SCHNEIDER
Schneider AG DUAL GmbH
Silvastraße 1
D-86842 TÜRKHEIM

Service - Info

Unit : Chassis TV 9.xx

No.: 245

No.: 246

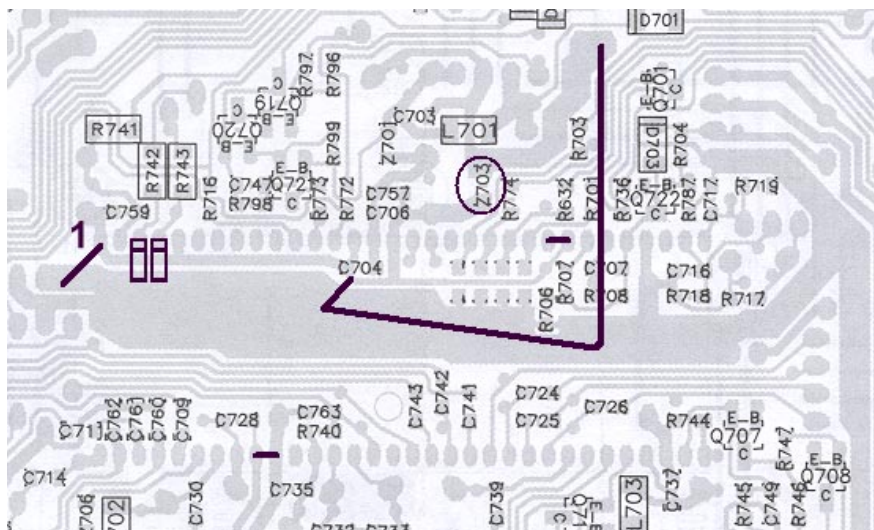
Failure of the horizontal deflection Q 304

Following parts have to be componented, controled or removed:

- 1.) A cap cable high voltage - transformer diode split has to be componented
- 2.) The software IC 902 has to be changed through the latest version
- 3.) A circuit connection has to be soldered in from Pin 1 / IC 701 to ground (look the sketch)
- 4.) A circuit connection has to be soldered in from C 704 to ground (look the sketch)
- 5.) The chip Z 703 has to be removed
- 6.) A circuit connection has to be componented like the sketch (six centimetre long)
- 7.) A circuit connection has to be soldered in from IC 701 / Pin 24 to Pin 25
- 8.) A circuit connection has to be soldered in from IC 701 / Pin 55 to Pin 56
- 9.) Two Diode BZT55C 5,6V have to be soldered in from IC 701 / Pin 3 and 4 to ground (anode to ground)

Attention: The modification's was already integrated in production, therefore a modification isn't necessary in all cases.
The changing of IC 902 is only necessary, if the Diode BZT55C wasn't componented in production.

No.: 252

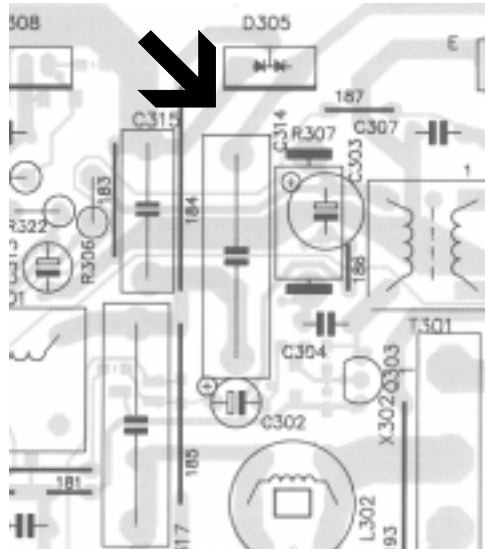
Concern: High frequency whistling

Remedy: The high frequency whistling may be caused by coming into contact of the fitting clip / diode D 305 with the capacitor in position C 314. For remedy the capacitor in position C 314 has to be replaced by a smaller version.

Part number capacitor for chassis TV 9.1: 0100865
Part number capacitor for chassis TV 9.3: 0109085

Concern: Rectifier / Chassis TV 9.XX (pos. D 102)

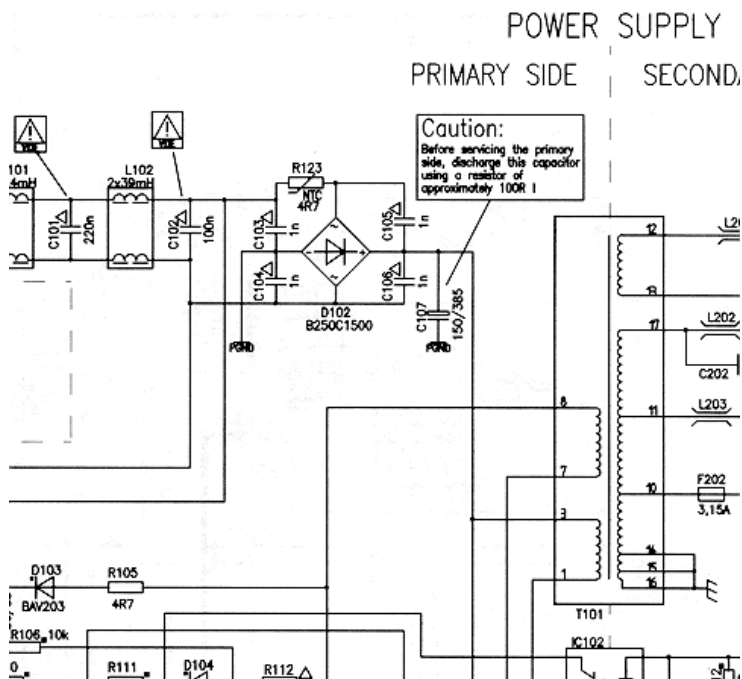
In case of service the rectifier in position D 102 has to be replaced by the replacement version alike the below declared sketches.

Rectifier „ old “ version

Rectifier „ new “ version

Spare part number rectifier „ new “ version : 0038833

No.:236

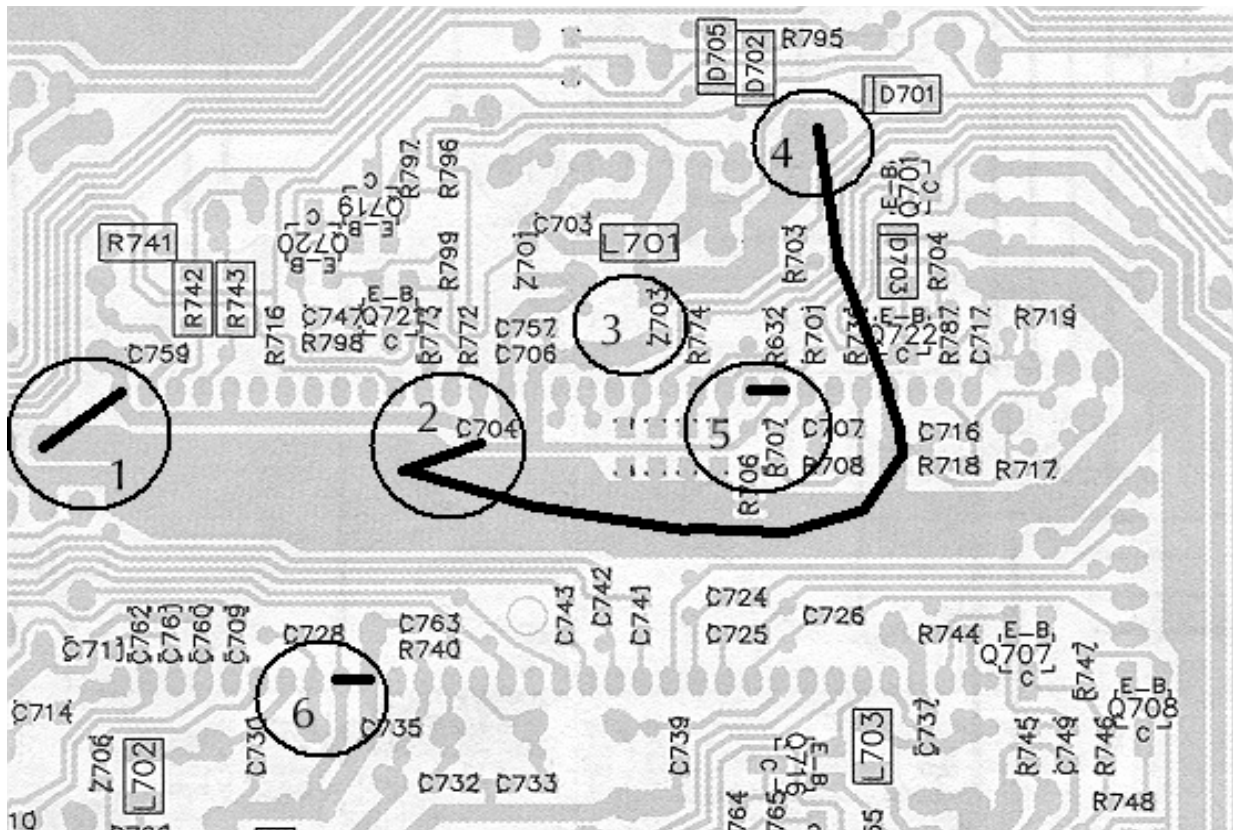
Concern: Improvement of the immunity from static discharge.

Remedy: Following parts have to be componented or removed respectively:

Main p.c.b. / IC 701 (wiring side):

| ❶ Short circuit connection Pin 1 IC 701 ⇒ ground | ❷ Short circuit connection C 704 ⇒ ground |
| ❸ Chip „Z 703“ has to be removed | ❹ Short circuit connection, laying according to below declared diagram (lenght 60 mm) |
| ❺ Short circuit connection IC 701

Pin 24 ⇒ Pin 25 | ❻ Short circuit connection IC 701
Pin 55 ⇒ Pin 56 |

Attention: The modification 1, 2 and 5 are already integrated up to board number 0109040.

No.: 243

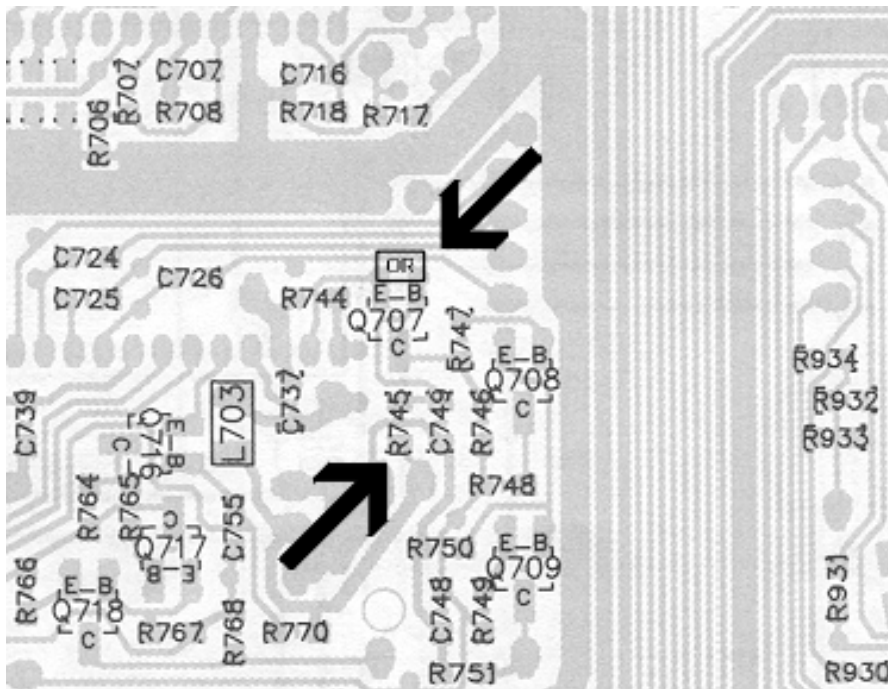
Concern: Vertical stripes at the right side behind the OSD

Remedy: Following parts have to be replaced or componentd respectively

- The chip resistor in position CR 745 (100 Ω) has to be removed and replaced by a 0 Ω version
- Between emitter and basis from transistor a 0 Ω chip resistor has to be componentd additional (like illustration)

Part number chip resistor 0 Ω : 0100060

Chassis	TV 9.3 in connection with picture tube type W 66 ECK 001X13
Concern:	Unsynchronizing PIP picture (PIP-module version 3)

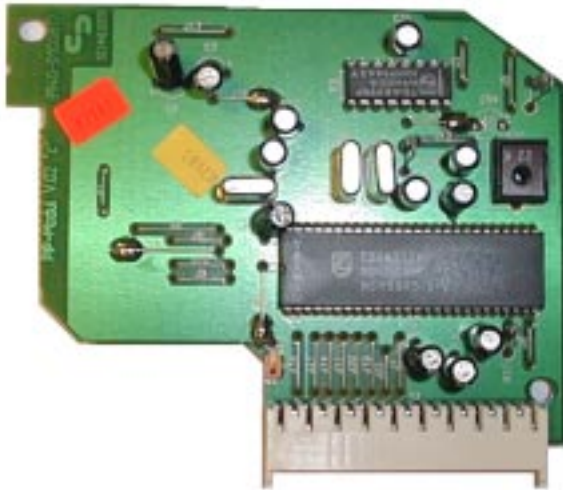
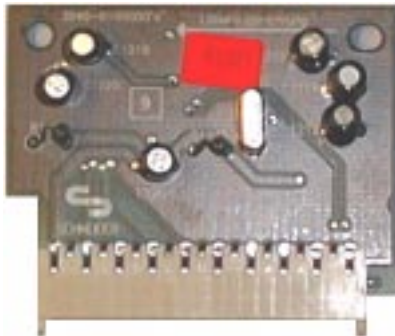
PIP-module version 1 and 2 : Modification not necessary

PIP-module version 3: The Chip resistor in position R 1204 has to be removed and replaced by a 270 Ohm / 150V chip resistor. The chip diode BZT55C in position D1202 has to be componented in addition.

Spare part number: Chip resistor 270 Ohm	0100090
Chip diode BZT55C	0100683
